SITE CONNECTION PROPOSAL FORM
VALID FOR TWO (2) YEARS

[SCP - 19285 /]

Borough of Brooklyn Building Dept. No (s) 321600665
Tax Block 3511 Lot (s) 64 Zoning R6 Map No. 17B
Project Location 638 Howard Avenue
Applicant Dmitriy Morozov, P.E.
Address 1460 Broadway, New York, NY Zip 10036 Phone (212) 330-7634
Owner Norman Cox, Union Street Studio LLC
Address 78 Union Street, Brooklyn NY Zip 11231 Phone (718) 596-3040

Drawing Title
SITE UTILITY PLAN
HYDRAULIC CALCULATIONS

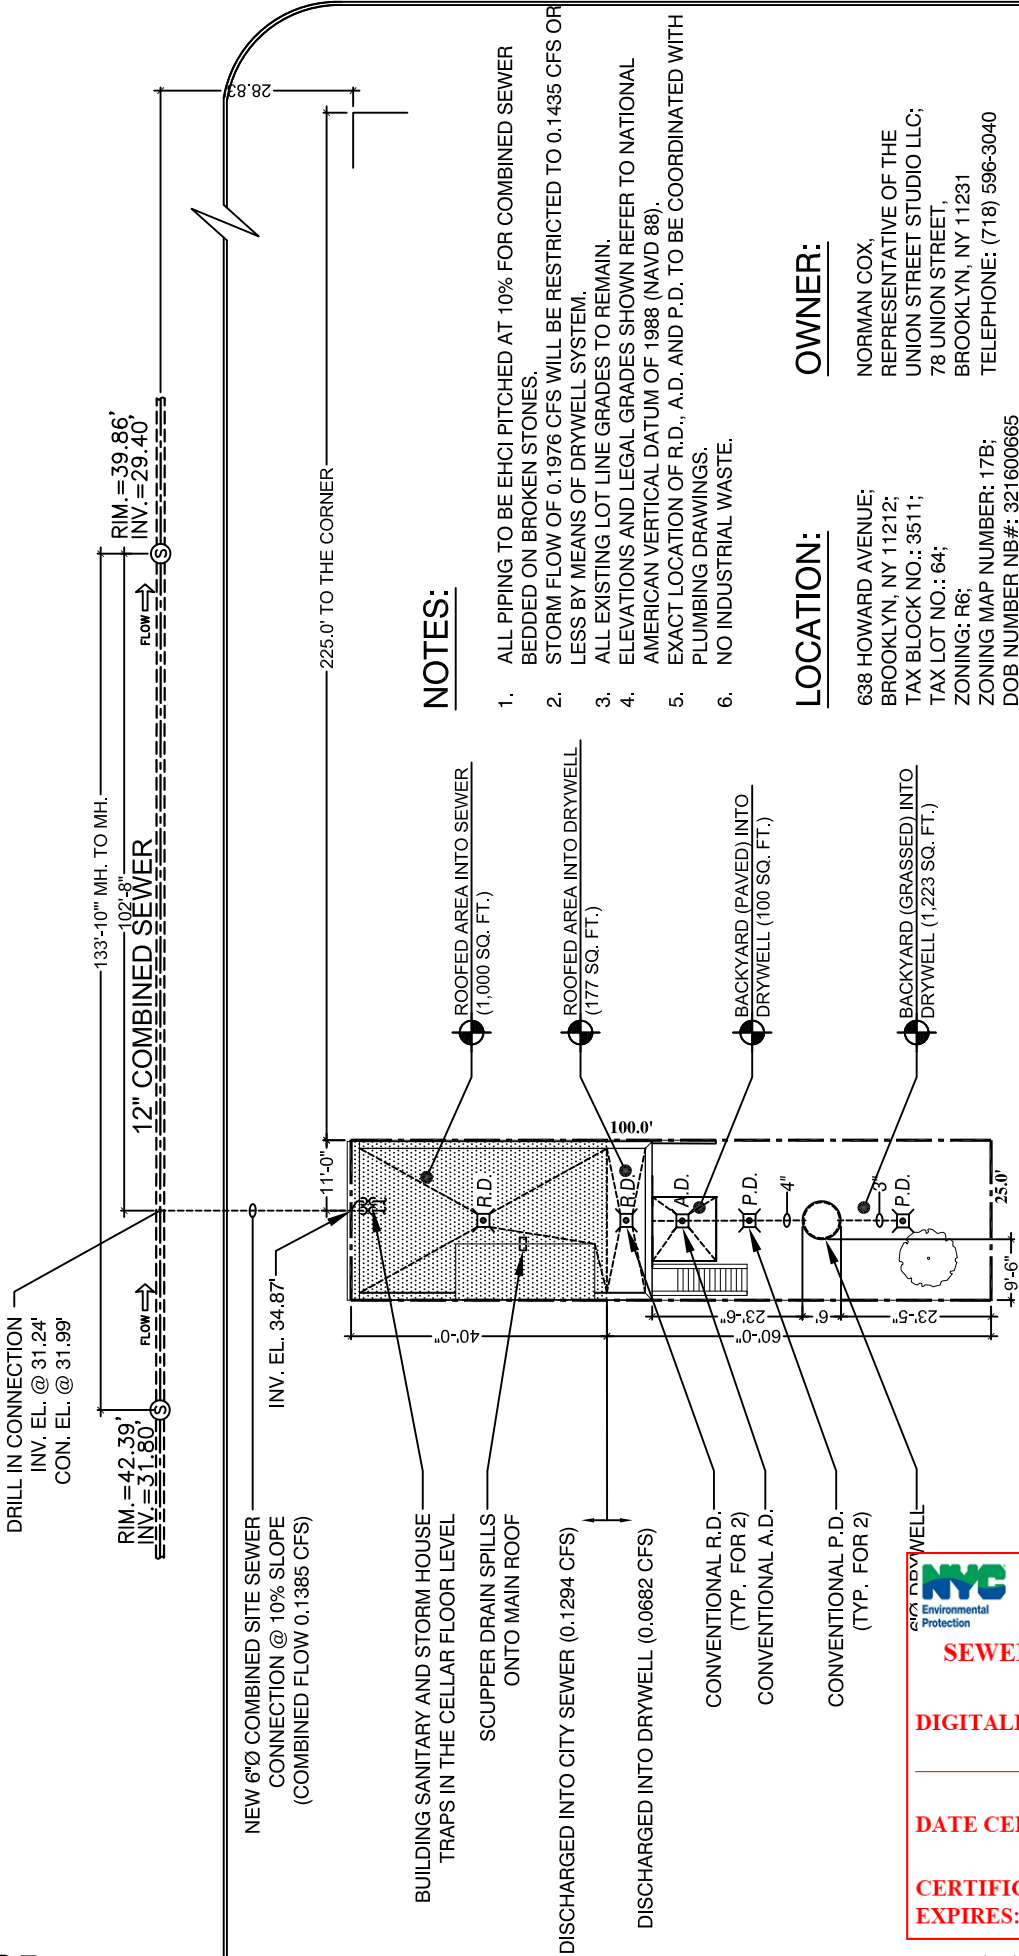
Storm flow of 0.1976 CFS will be restricted to ~~0.1435~~ CFS or less by means of retention system.
0.1294 cfs

No conn. permit issued until DOB certifies the retention facility has been satisfactorily installed.
